Project	IEEE 802.16 Broadband Wireless Access Working Group < http://ieee802.org/16 >	
Title	Clarification of renumbering and permutation based on DL_PermBase parameter	
Date Submitted	2005-04-22	
Source(s)	Sean Cai Jason Hou LiuJun Hu ZTE San Diego Inc. 10105 Pacific Heights Blvd. San Diego, CA 92121 USA	scai@ztesandiego.com jhou@ztesandiego.com Voice: 858-554-0387 Fax: 858-554-0894
Re:	IEEE 802.16 WG Recirculation Ballot #17a on P802.16-2004/Cor1/D2	
Abstract	This contribution is for clarification of renumbering and permutation based on DL_PermBase parameter	
Purpose	To incorporate the text modification proposed in this contribution into P802.16-2004/Cor1/D3.	
Notice	This document has been prepared to assist IEEE 802.16. It is offered as a basis for discussion and is not binding on the contributing individual(s) or organization(s). The material in this document is subject to change in form and content after further study. The contributor(s) reserve(s) the right to add, amend or withdraw material contained herein.

Clarification of renumbering and permutation based on DL_PermBase parameter

Figure 219—Illustration of OFDMA frame with multiple zones

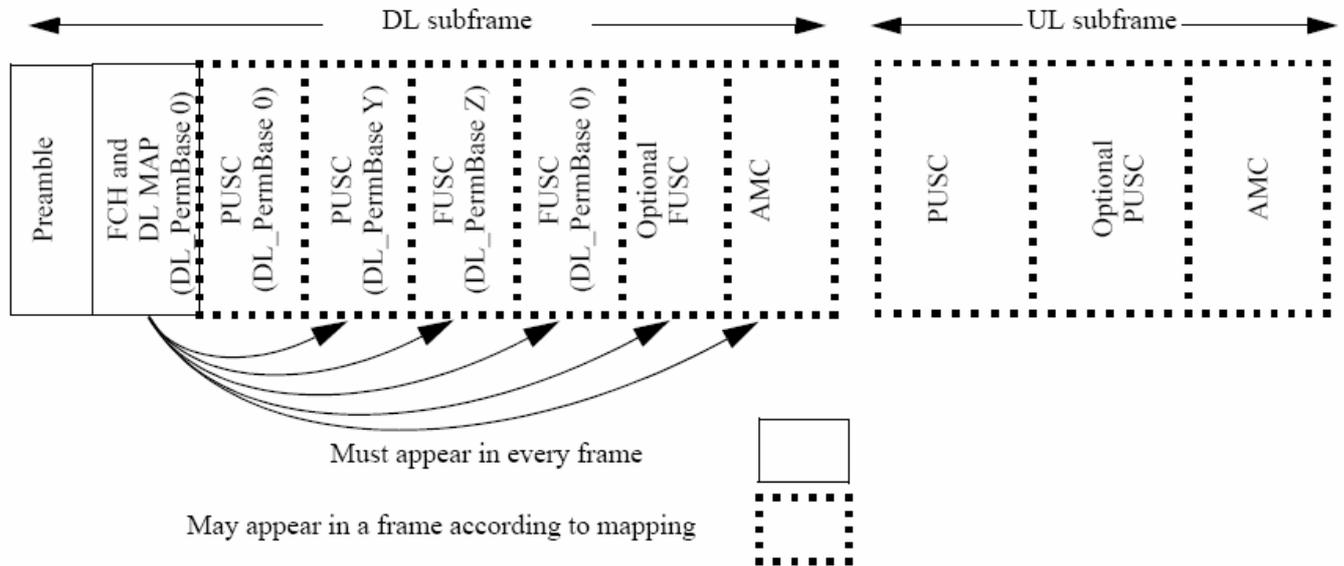
Replace Figure 219 with the following figure:

[The DL_PermBase = 0 in the first zone which includes FCH and DL MAP. It's better to indicate that IDcell = X in the figure after Preamble.]
